Town of Hilton Head Island
Regular Design Review Board Meeting

Tuesday, December 13, 2011
1:15 p.m. – Benjamin M. Racusin Council Chambers

AGENDA

Alternate location for platform F does not require shifting of course and provides more stable anchor point for bridge

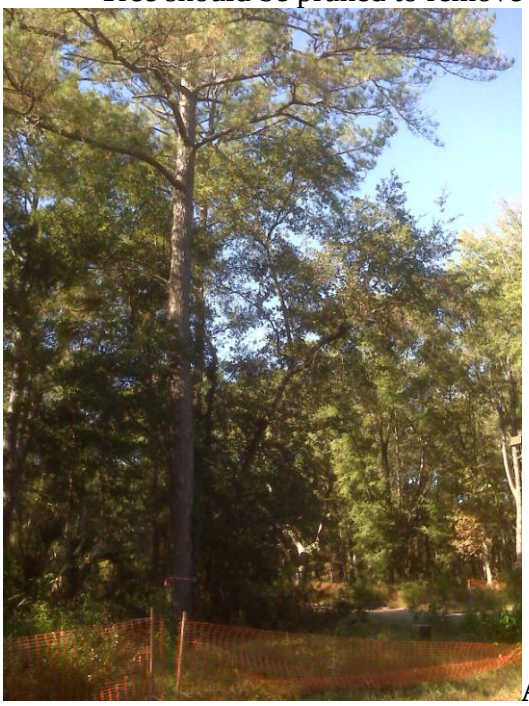
- Tree should be considered as alternate location for platform (30” Laurel Oak had multiple cavities and decay points and was not suitable for bolt installation)
- Tree should be pruned to remove large deadwood and weak branches

Laurel Oak- Dual stems originating near base high potential for failure

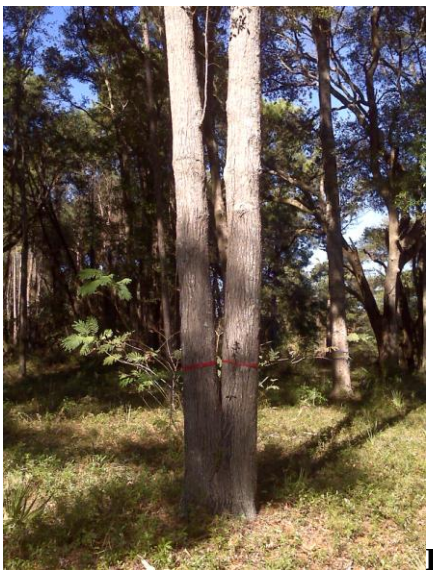
- Tree has dual stem near base of tree causing opposing forces created by competing stems that show some indication of stress and tip decline

Site Plan

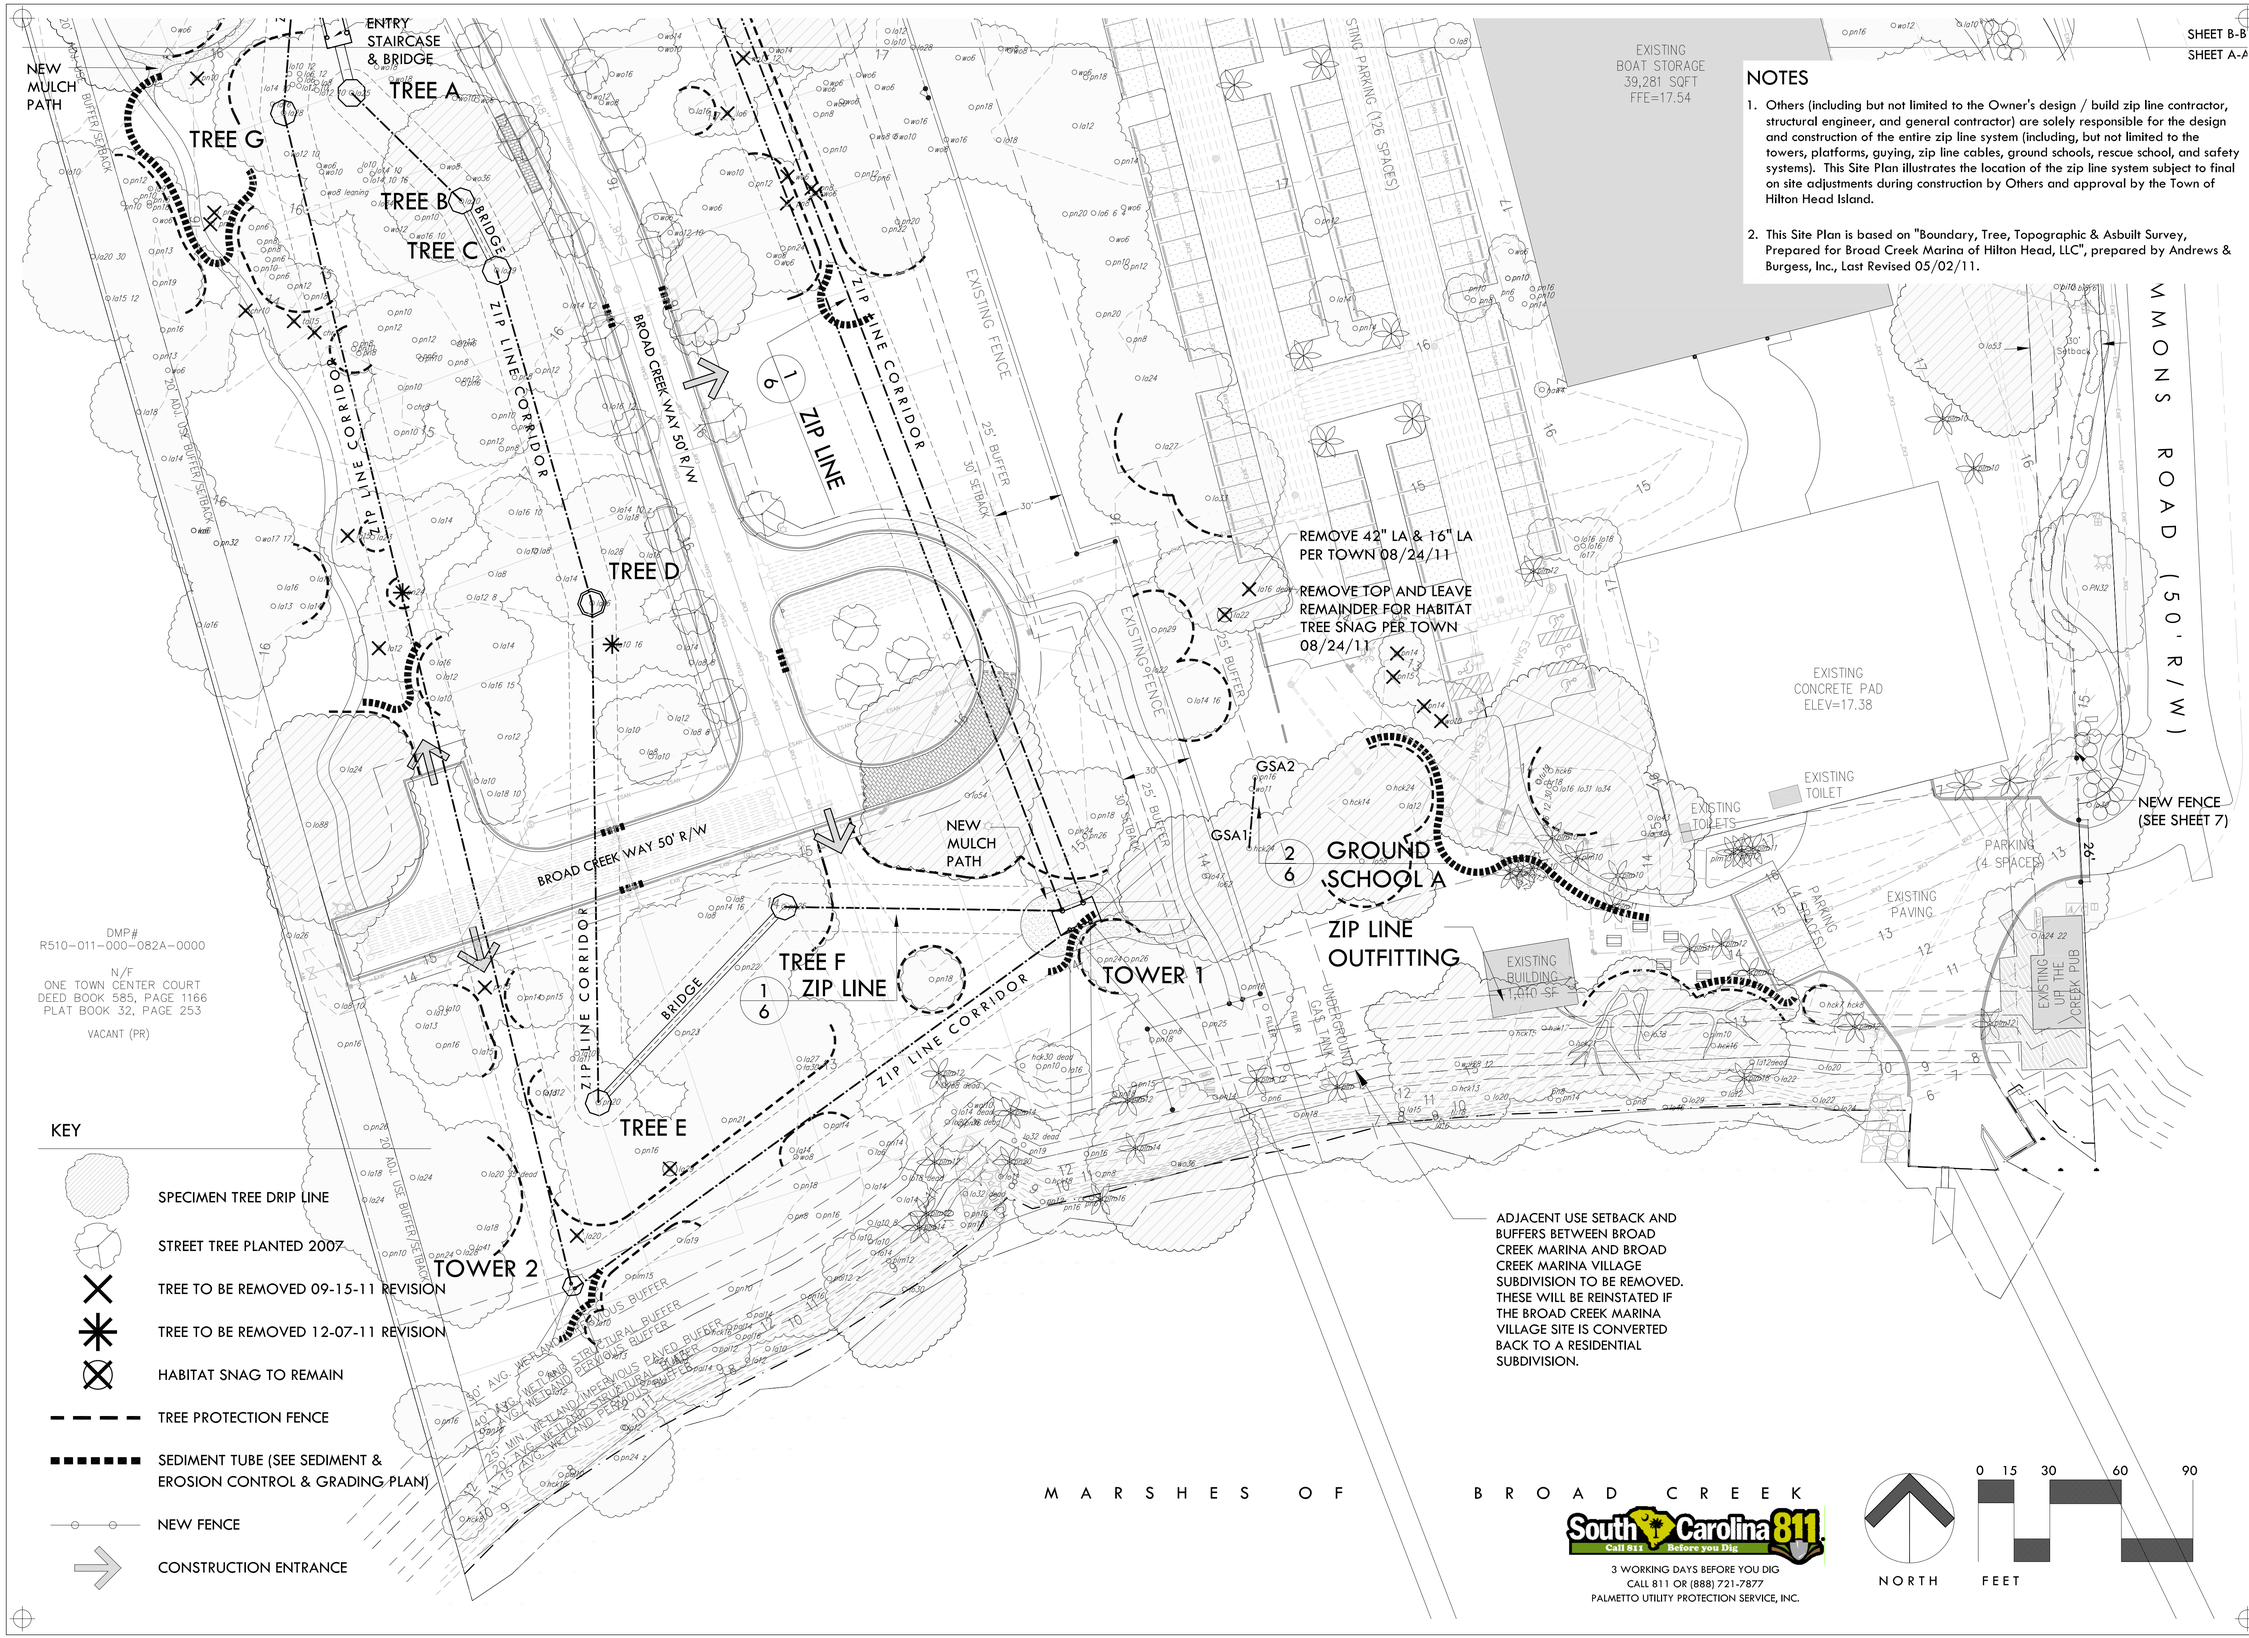
12-07-11 4 Revise Zip Line layout to reduce number of towers and add Zip Line platforms in trees.
Sheet 1 Add revisions.
Sheet 2 Revise Zip Line layout: add Ground Schools A & B and Rescue School: add summaries: move "Road / Parking Clearance" detail to Sheet 6.
Sheet 3 Revise Zip Line layout: add Ground School A.
Sheet 4 Revise Zip Line layout: add Ground School B and Rescue School.
Sheet 5 Revise Tree Removal Tally and Tree Pruning and Removal Notes.
Sheet 6 Add "Road / Parking Clearance" detail from Sheet 2: delete "Tree Protection", "Sidewalk", and "Protective Bollards" details: add illustrations for "Conceptual 4-Pole Zip Line Tower", "Conceptual 2-Pole Zip Line Tower" and photos of "Typical Zip Line Tree Platforms".
Sheet 7 Change sheet title to "Simmons Road Fence Plan".

Sheet 5 Of 7

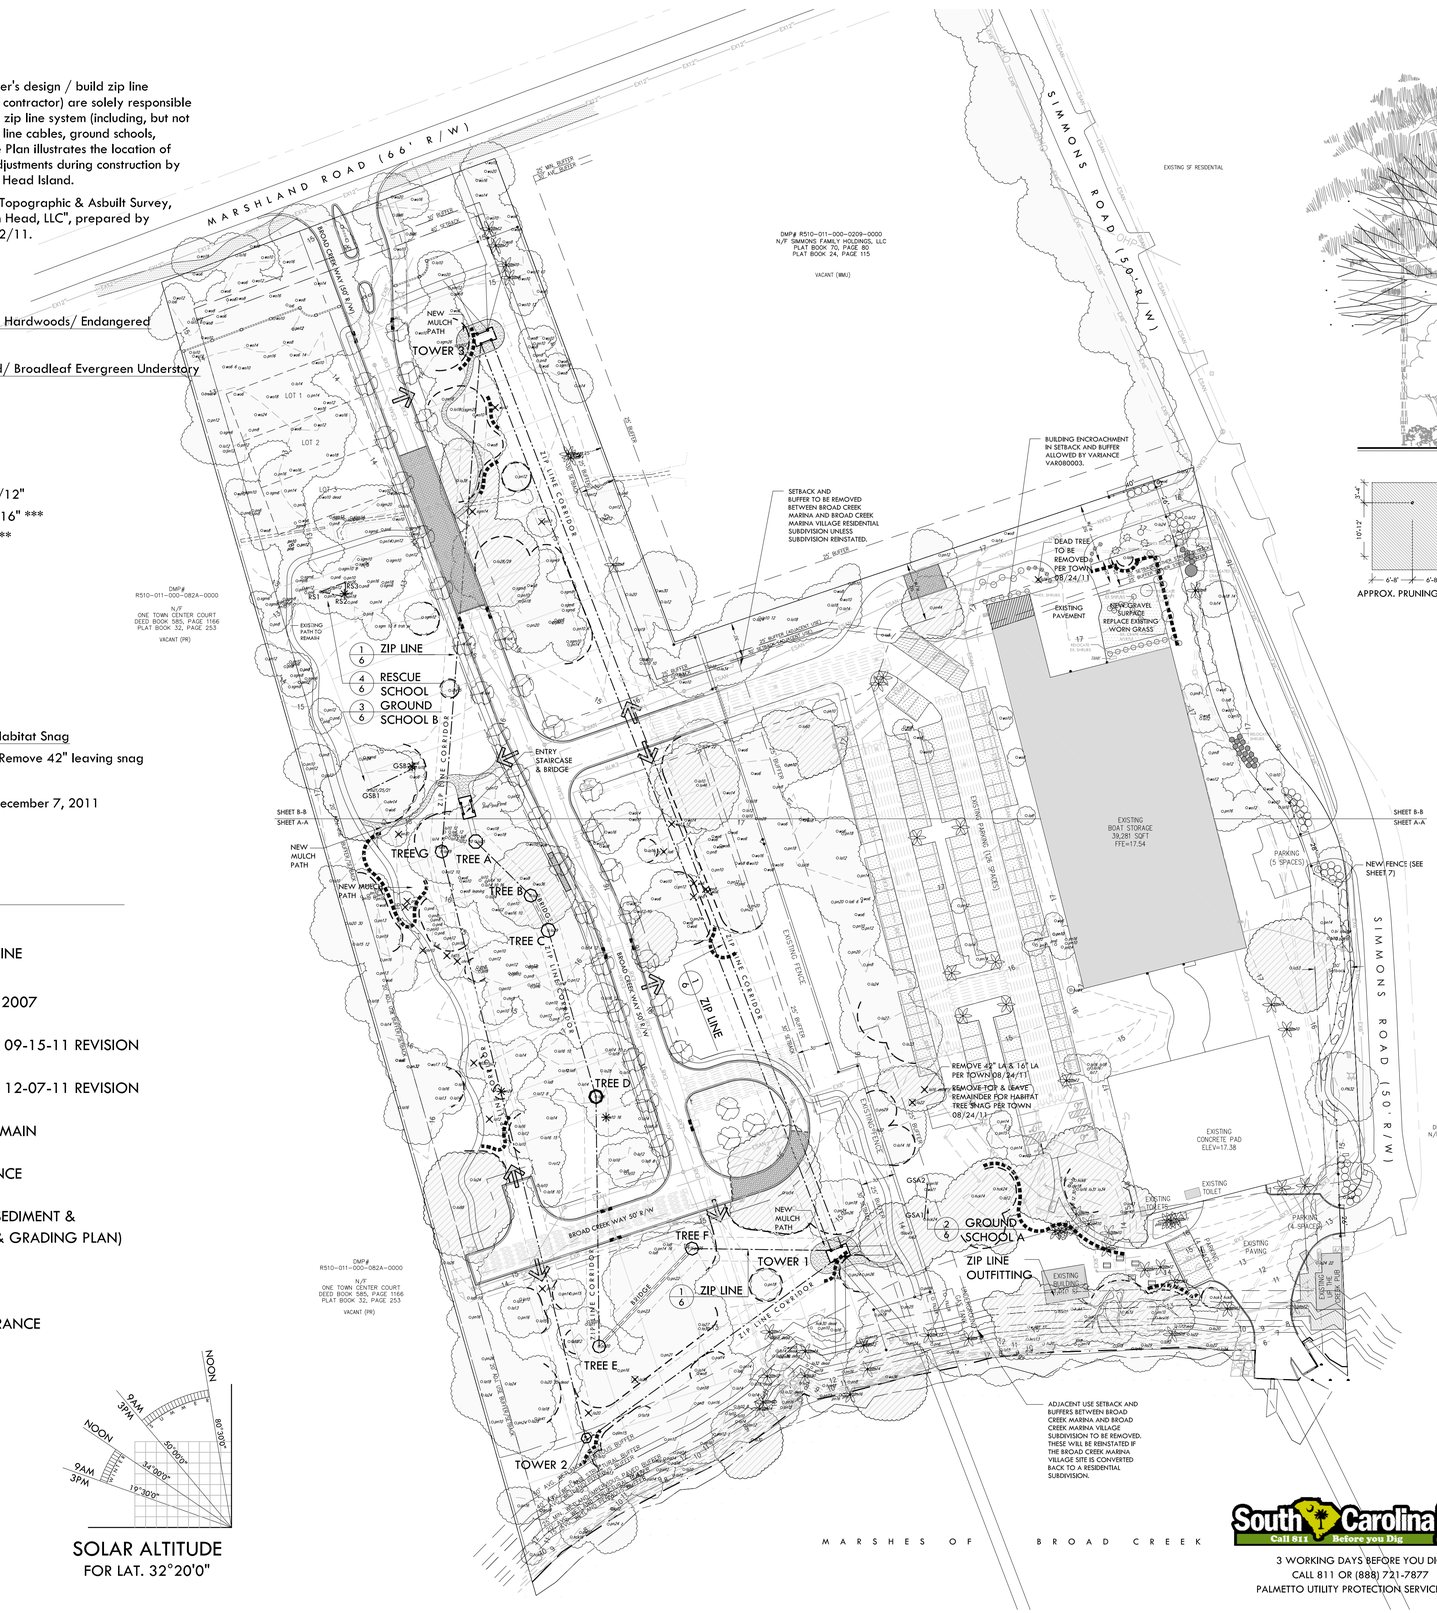
Following Town DPR approval of the Site Development Plan (Revised 09-15-11), the Applicant engaged the services of S.T.E.P.S. and the layout for the zip line was revised and the Ground Schools and Rescue School were added as indicated on these plans revised 12-07-11.
2. The zip line design calls for a careful placement of ten (10) zip line Platforms (labeled A thru J) three (3) platform towers and seven (7) platform trees to minimize impact to the forest's trees and the tree canopy with minimal tree removal and careful pruning of limbs as preliminarily determined in the field.
3. Tree removal and pruning to be supervised by a Town of Hilton Head Island approved certified arborist.
4. Pruning shall meet Town of Hilton Head Island LMO Standards and the "Typical Zip Line Pruning" detail herein.
